SOLICITATION ADDENDUM NO. 1

ITB 21-0016

Summit Building- Tenant Improvements- General Contractor

BIDDING ADDENDUM 1

ELECTRICAL DEMOLITION PLAN - LEVEL 1
 1/8" = 1'-0" 1

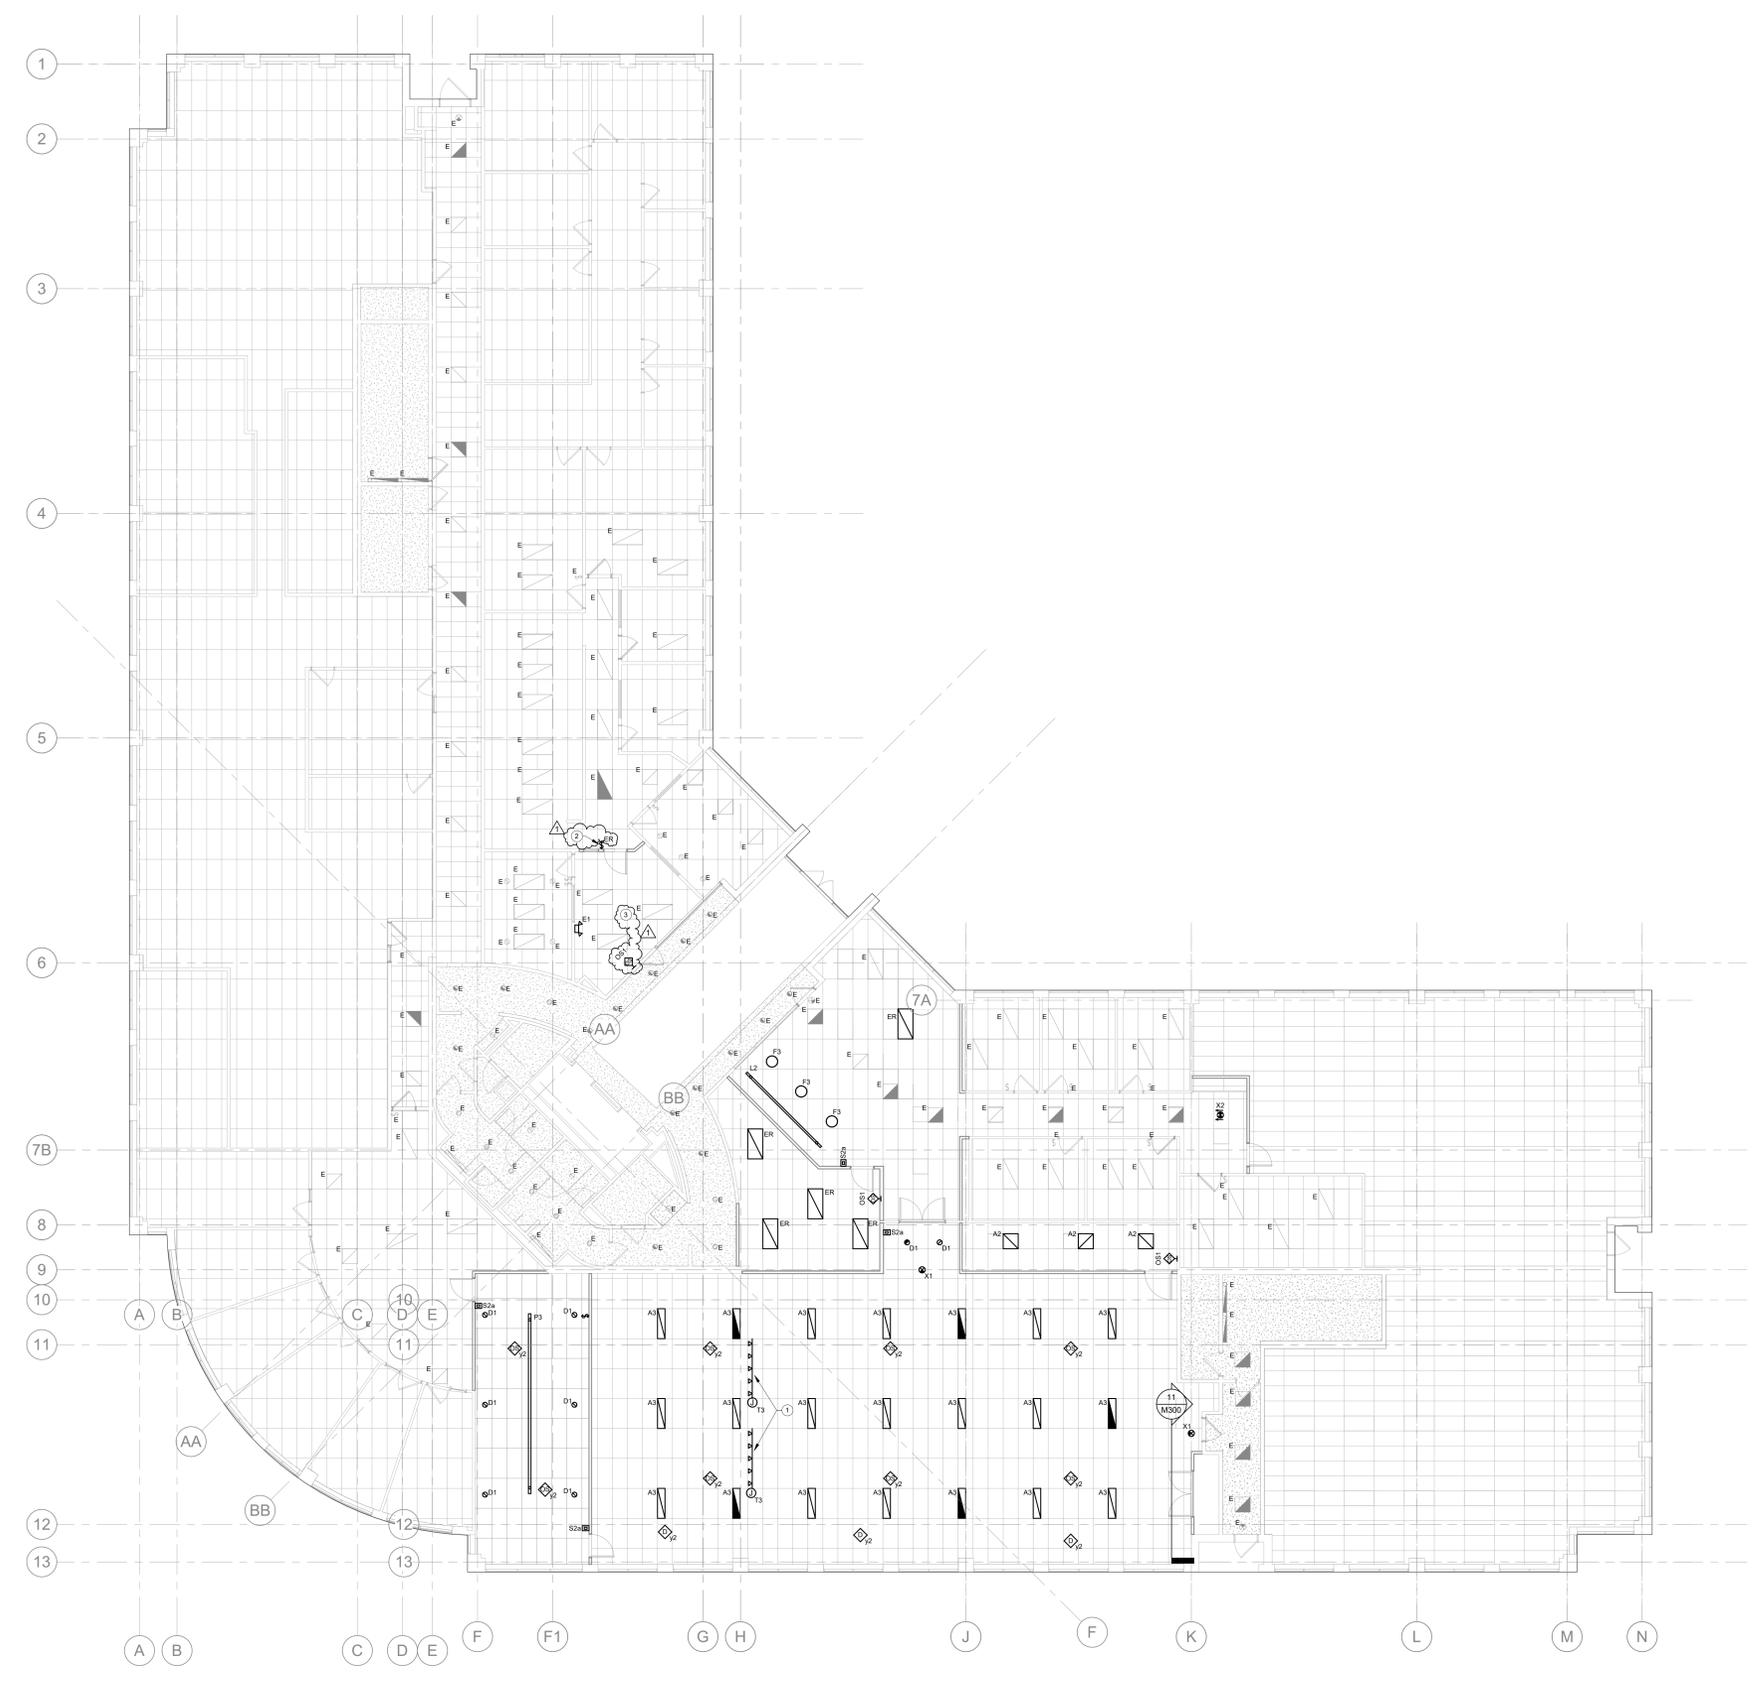
1. Drawing ED101 – ELECTRICAL DEMOLITION – LEVEL 1:
 - a. **MODIFY** existing lighting control at office suite for room Waiting 111, remove and relocate.
2. Drawing E101 – ELECTRICAL LIGHTING PLAN – LEVEL 1:
 - a. **MODIFY** existing lighting control for office suite, show relocated relay/override switch controls.
 - b. **MODIFY** existing lighting control for Waiting 111, show new circuiting requirements and occupancy sensor controls.
3. Drawing E301 – ELECTRICAL SCHEDULES:
 - a. **MODIFY** approved equals column to include manufacturer and series for select fixtures.

EXISTING OVERHEAD AND RELAY CONTROL FOR EXISTING OFFICE SUITE. REMOVE AND RELOCATE. SEE LIGHTING PLAN SHEET E101 FOR ADDITIONAL REQUIREMENTS.

TECHNOLOGY AUDIO VISUAL ELECTRICAL PLAN - LEVEL 2 1
1/8" = 1'-0"

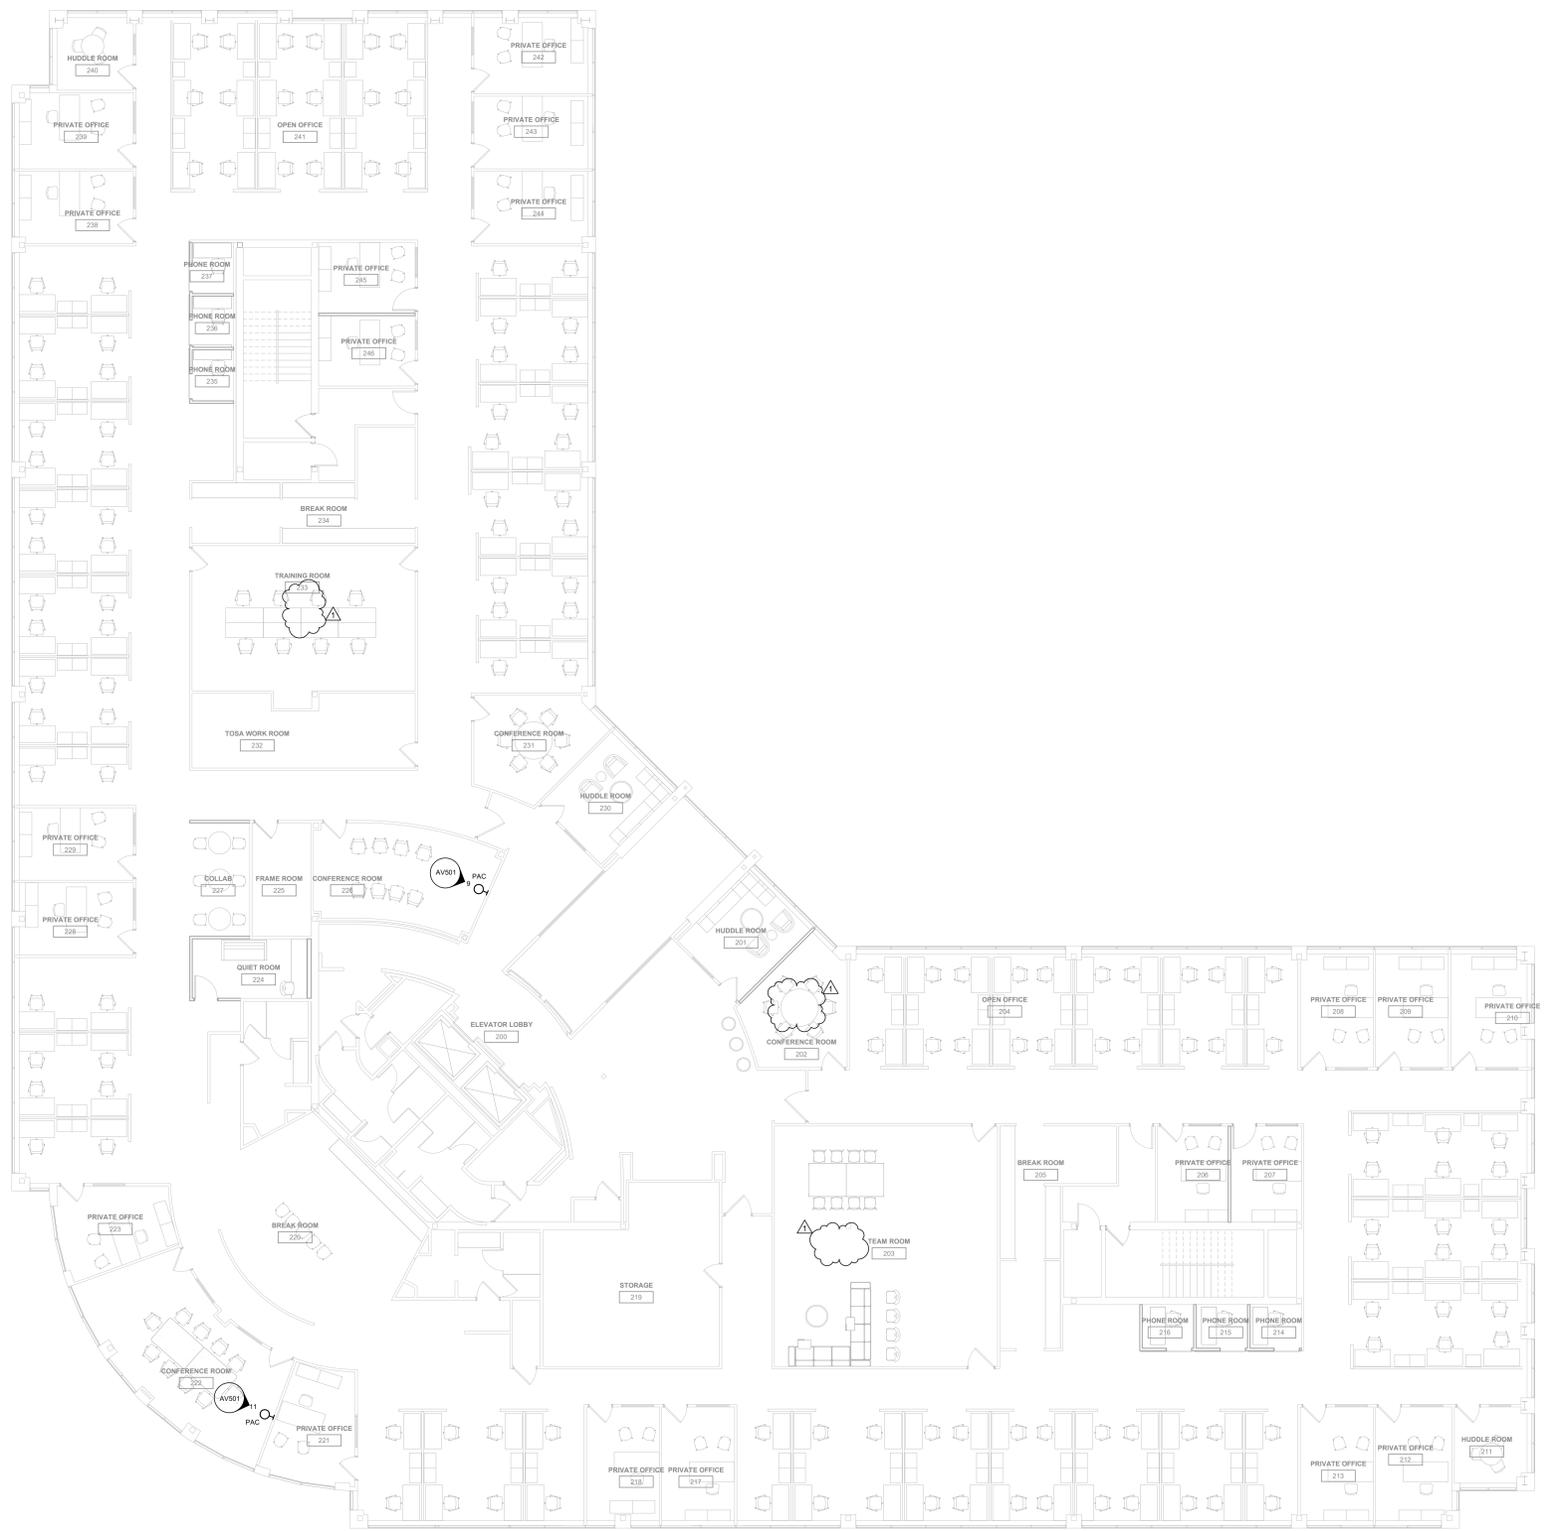
4. Drawing AV301 AV Electrical Plan Level 1
- a. General notes
 - i. **DELETE** elevation call outs for room where PAC boxes were removed.
5. Drawing AV302 AV Electrical Plan Level 2

- a. General notes
 - i. **DELETE** elevation call outs for room where PAC boxes were removed.
6. Drawing AV303 AV Electrical Plan Level 3
- a. General notes

TECHNOLOGY COMMUNICATIONS CEILING PLAN - LEVEL 1

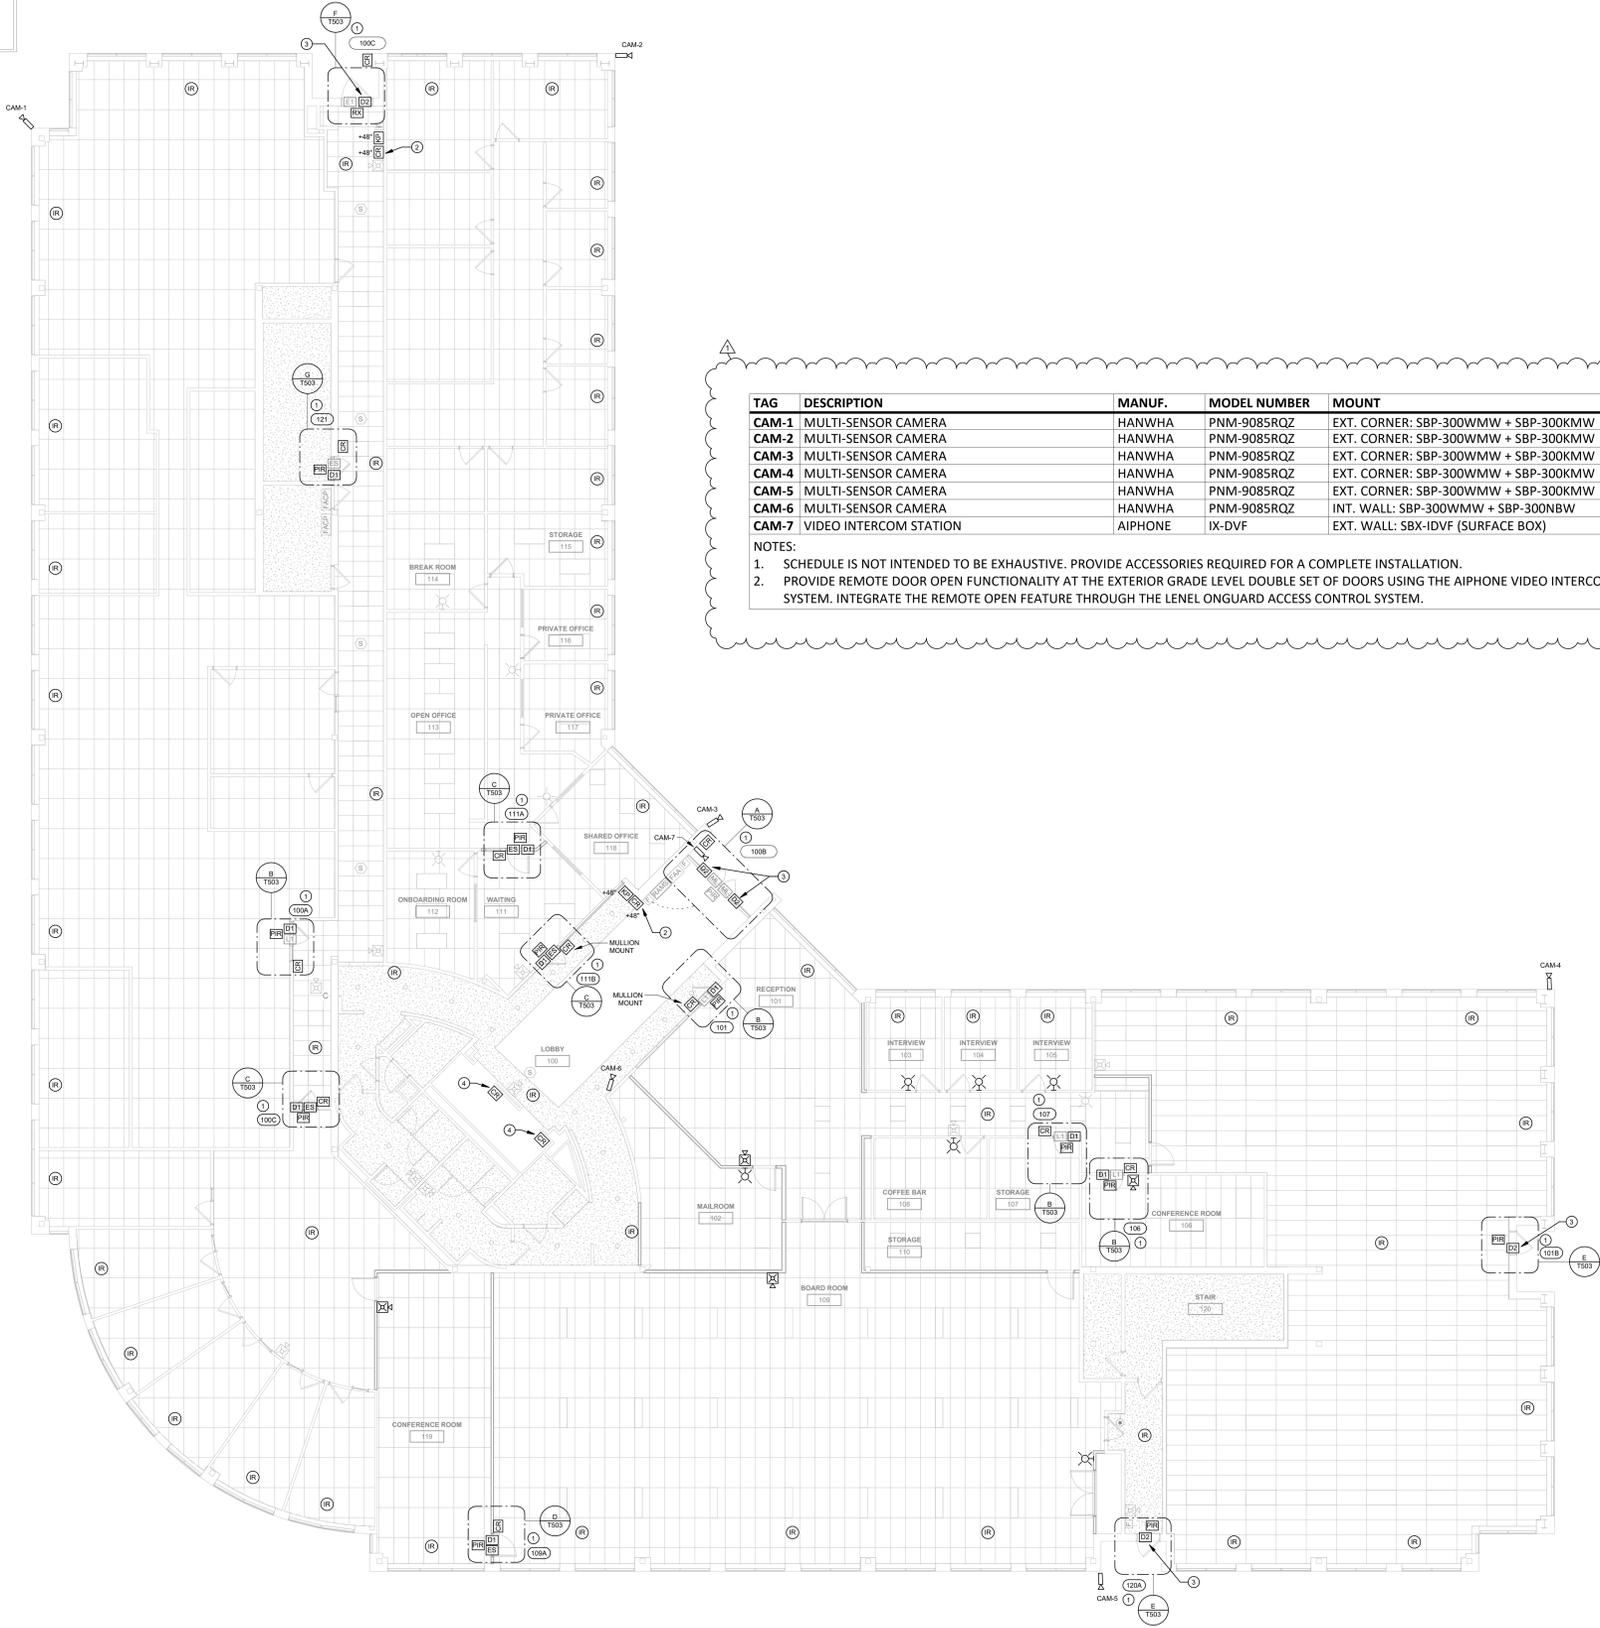
1. Drawing T201 – TECHNOLOGY COMMUNICATIONS CEILING PLAN – LEVEL 1:
 - a. Open Office 113
 - i. **MODIFY** the location of the southern most wireless access point. Relocate the cabling and termination to room Waiting 111.
2. Drawing T301 – TECHNOLOGY LIFE SAFETY & SECURITY PLAN – LEVEL 1:
 - b. Camera schedule
 - i. **MODIFY** CAM-1 model number in the schedule to be PNM-9085RQZ.
 - ii. **MODIFY** CAM-2 model number in the schedule to be PNM-9085RQZ.
